PARTS & SERVICE NEWS

REF NO.	AT00123
DATE	Jul. 17, 2000

SUBJECT: INTRODUCTION OF IMPROVED PISTON ROD AND NUT FOR S/T CYL. ON WA300-3 BLADE SPEC.

APPLICATION: WA300-3 Wheel Loaders, Serial Nos. 50001 thru 55114

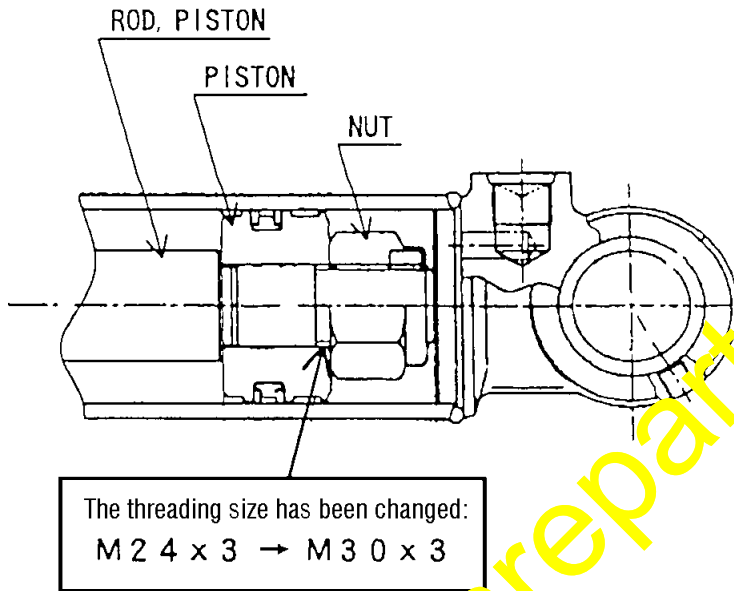
We increased the strength of the piston rod against the tensile strength occurring from the internal pressure by enlarging the threading size on the piston rod of the cylinder.

Threading sizes on the piston rod	
Before the modification	After the modification
M24 × 3	M30 × 3

No.	Part names	Part numbers	
		After the modification	Before the modification
1	Rod, piston	707-59-40091	707-59-40090
2	Piston	707-36-70270	707-36-70160
3	Nut	07165-13033	07165-12426

Note: The current parts and new parts are interchangeable in a set of Item Nos. 1, 2 and 3.
